To: Prospective Bidders
From: Wold Architects and Engineers
Date: March 24, 2015
Comm. No: 144012

Subject: Addendum No. 2 for Bidding Documents for the: **Madonna University Toilet Renovation
Livonia, Michigan**

PROJECT: MADONNA UNIVERSITY CENTER TOILET RENOVATIONS

R1
M2.1

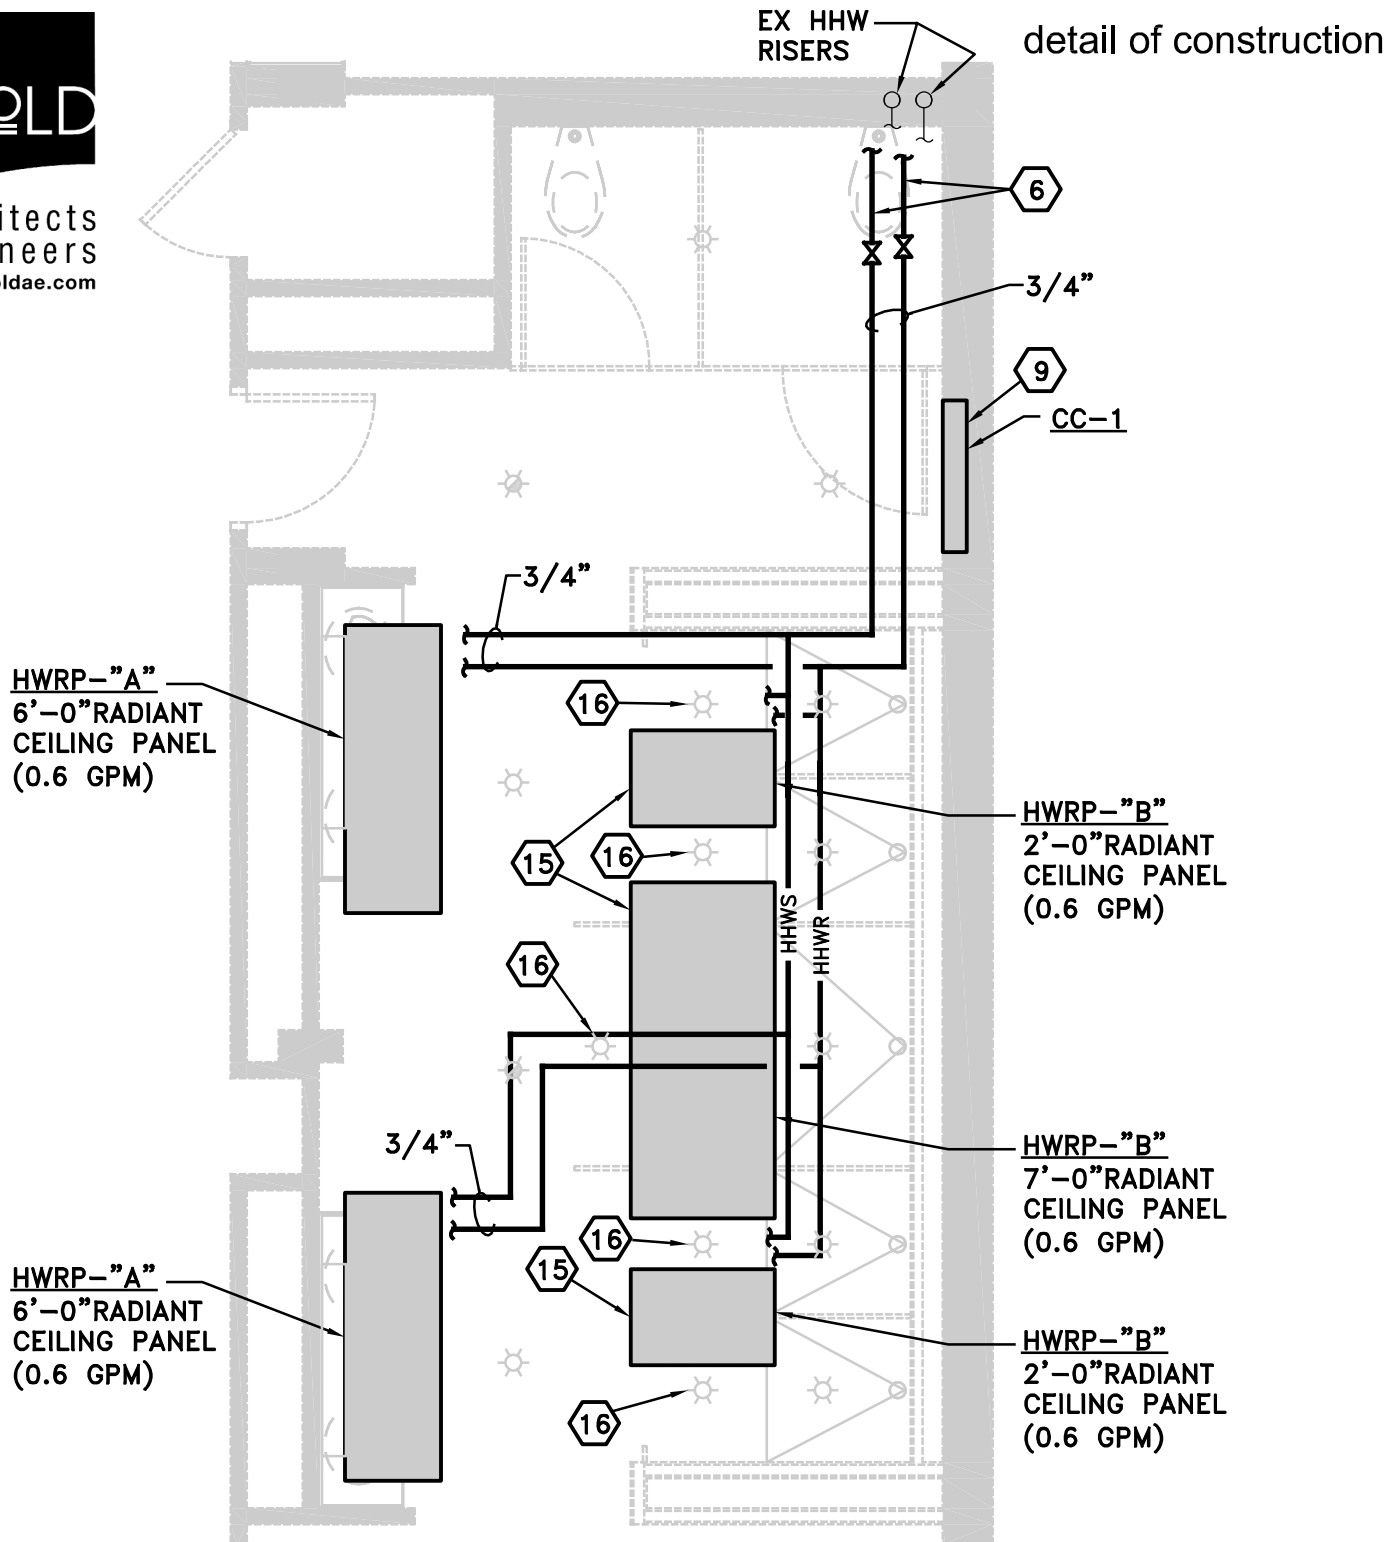
- A. Refer to Sheet M2.1 Area "B" Mechanical Revisions, and Sketch R1/M2.1. Install (3) 36" wide radiant panels in lieu of (2) 24" wide radiant panels as shown. Coordinate location of panels with downlights. Refer to Sheet M2.1 for exhaust ductwork. Exhaust ductwork was removed from Sketch for clarity.

- A. Relocate downlights as shown within Sketch R1/M2.1. Downlights shall be installed as close to center of shower changing area as possible.

- 15 DO NOT INSTALL RADIANT PANELS DIRECTLY ABOVE SHOWER. PANEL SHALL BE INSTALLED OUTSIDE OF SHOWER CURTAIN.
- 16 ADJUST LOCATION OF DOWNLIGHT FOR ABILITY TO INSTALL RADIANT PANEL. DOWNLIGHT SHALL BE INSTALLED CLOSE TO CENTER OF SHOWER CHANGING AREA AS POSSIBLE
